Access Compliance Report Public Rights-of-Way (Curb Ramps)

Main Street: COCKSCROW_LN		Cross Street: HICKORY_BRANCH_RD		Location:	S
ADA ID: RPRK220103143924	Ramp Type: Type 4 - Parallel	Initial Pass/Fail: Fail	Overall Compliance: No	Severity Score:	16

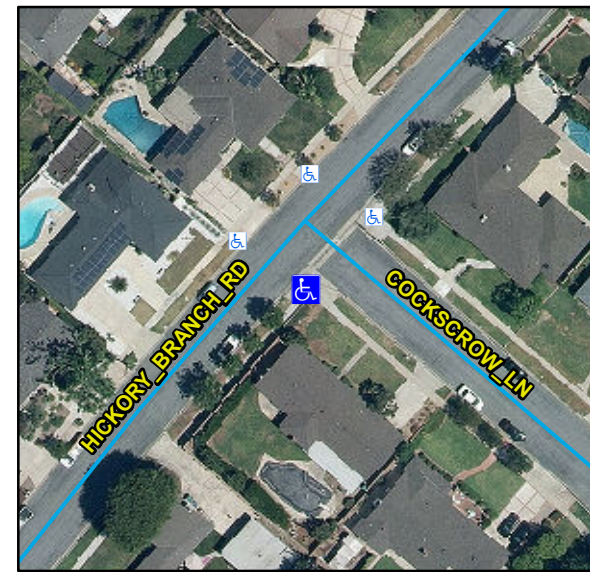
Compliance	Description	Data	Compliance	Description	Data
N/A	Ramp Length LT (in)	173	N/A	Ramp Length RT (in)	147
Yes	Ramp Width LT (in)	107	Yes	Ramp Width RT (in)	94
No	Ramp Run Slope LT (%)	8.5	Yes	Ramp Run Slope RT (%)	3.2
Yes	Ramp Cross Slope LT (%)	1.2	No	Ramp Cross Slope RT (%)	3.3
N/A	Landing Present	N/A	N/A	DWS Provided	N/A
N/A	Landing Length (in)	N/A	N/A	DWS Contrast	N/A
N/A	Landing Width (in)	N/A	N/A	DWS Length (in)	N/A
N/A	Landing Run Slope (%)	N/A	N/A	DWS Full Width	N/A
N/A	Landing Cross Slope (%)	N/A		DWS Offset Type	N/A
N/A	Landing Movement Obstructed?	N/A	N/A	DWS Offset Left (in)	N/A
	Landing Movement Type	N/A	N/A	DWS Offset Right (in)	N/A
N/A	Landing Shared	N/A			
N/A	Clear Space	Yes			
N/A	Clear Space To Crosswalk (in)	N/A			
N/A	Marked Crosswalk 1	No	N/A	Marked Crosswalk 2	No
	Crossing 1 Direction	NE		Crossing 2 Direction	NW
N/A	Marked Crosswalk 1 Width (in)	N/A		Marked Crosswalk 2 Width (in)	N/A

N/A	Ramp Inside Crosswalk 1	N/A	N/A	Ramp Inside Crosswalk 2	N/A
	Crossing 1 Slope (%)	6.5		Crossing 2 Slope (%)	1.8
	Crossing 1 Cross Slope (%)	5		Crossing 2 Cross Slope (%)	3.4
N/A	Gutter Ponding	N/A	N/A	Curb Slope	3.9
Yes	Gutter Lip Height (in)	0		Road Run Slope (%)	2.7
N/A	Gutter Run Slope (%)	N/A		Road Cross Slope (%)	1.2
N/A	Gutter Cross Slope (%)	N/A	No	Perpendicular Joint Present	No
Yes	Overall Surface Condition	Acceptable			
	Cross Gutter Present?	Yes		Spandrel Present?	Yes
	Replace Cross Gutter?	No		Replace Spandrel?	No

Remove & Replace Curb Ramp With Two New Directional Ramps or Equivalent.
